SERVICE BULLETIN 0807-001
3-30-2009, Revision A

MULTI-GROOVE SUPERCHARGER BELT

Cessna 182 aircraft models G through Q, serial numbers 18255101 through 12855125 and 18255845 through 18266590 modified with Forced Aeromotive Technologies supercharger systems, STC # SA10232SC and SE10233SC.

Figure 1

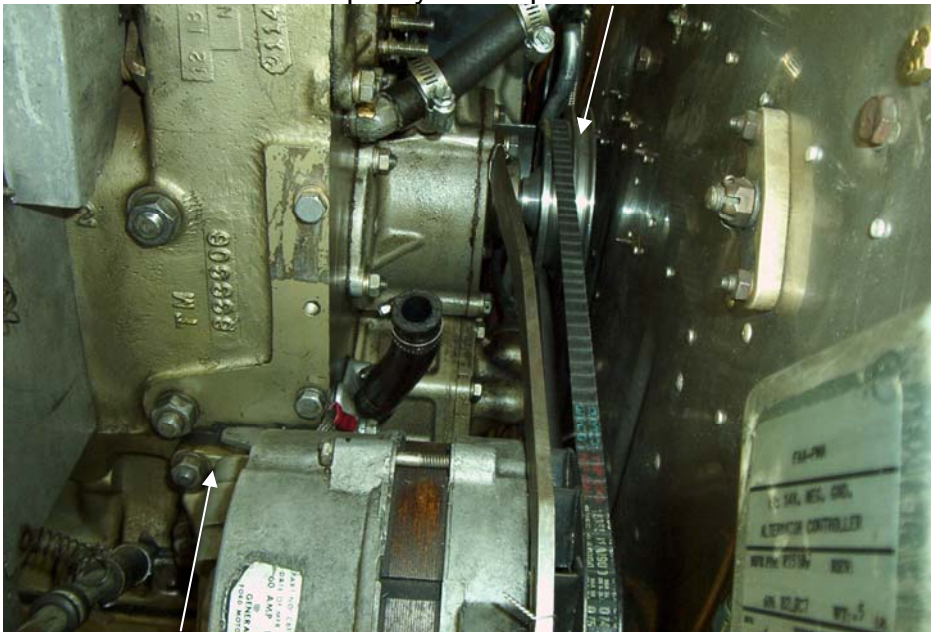
1. Disconnect the battery.
2. Remove the upper and lower cowling.
3. Loosen the engine mount bolts at the firewall and using a hoist, slide the engine forward about 2 inches.
4. Loosen the supercharger idler and remove the supercharger belt and loosen the alternator and remove the alternator belt. Remove the alternator and remove the 4 nuts and washers securing the alternator support to the engine remove and modify the support per FAT Inc. drawing P/N 182LR0116, or P/N 182LR0017, or P/N 182LR0018 as appropriate. (figure 1)
5. Reinstall the modified alternator support and alternator.
6. Remove the alternator/supercharger drive pulley from the rear of the engine and replace it with the new double pulley, P/N182LR014-2, using the existing hardware. Tighten to 37.5 to 41.2 ft. lbs. (Figure 1)

Remove drive pulley and replace with P/N 182LR014-2

Alternator support

Figure 2

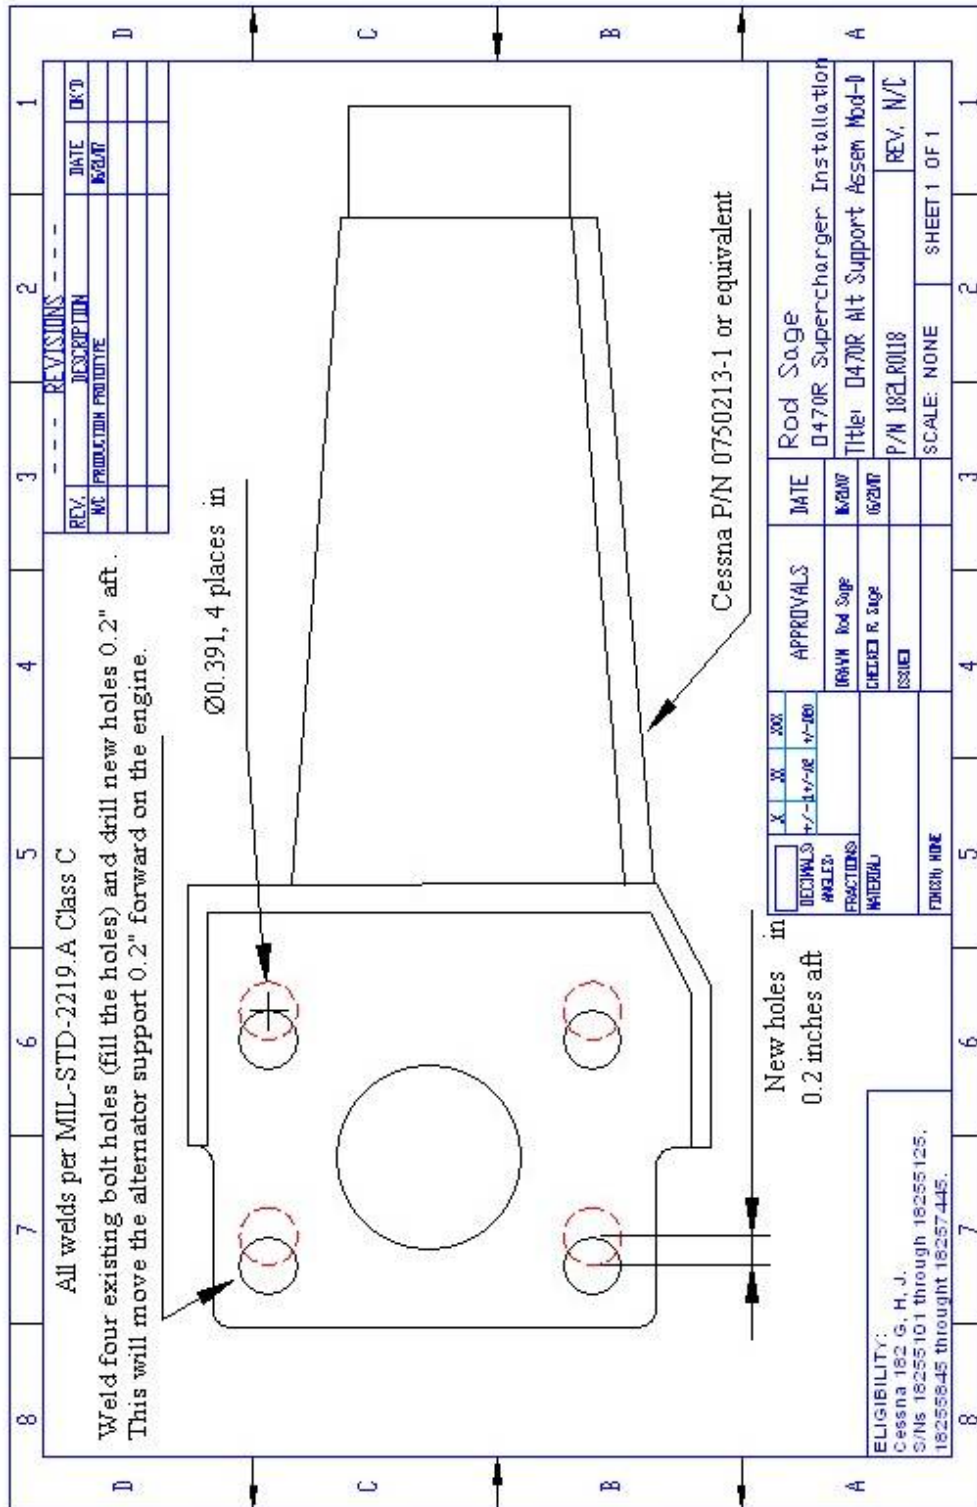
7. Reinstall the alternator belt, FAT P/N 182355, and tighten the belt by rotating the alternator. (Figure 1)
8. Remove the supercharger pulley (figure 2) and replace it with pulley P/N 182LR009-2 using the existing hardware.
9. Install the supercharger belt, FAT P/N182LR440-M or 182U450-M, and tighten the belt by pushing down on the idler pulley, tensioning the belt . Tighten the belt until a 9.5 lb. pull at the center of the lower portion of the belt results in a .25 inch of belt deflection. Recheck belt tension in the first 2-10 hours and adjust to a setting of 7.0-8.0 pounds.
10. Reinstall the engine and confirm clearance of all cables, hoses, wires, etc.
11. Reconnect the battery.
12. Check engine operation with a ground run.
13. Reinstall the cowling.

Supercharger idler

Remove supercharger pulley, replace with P/N 182LR009-2
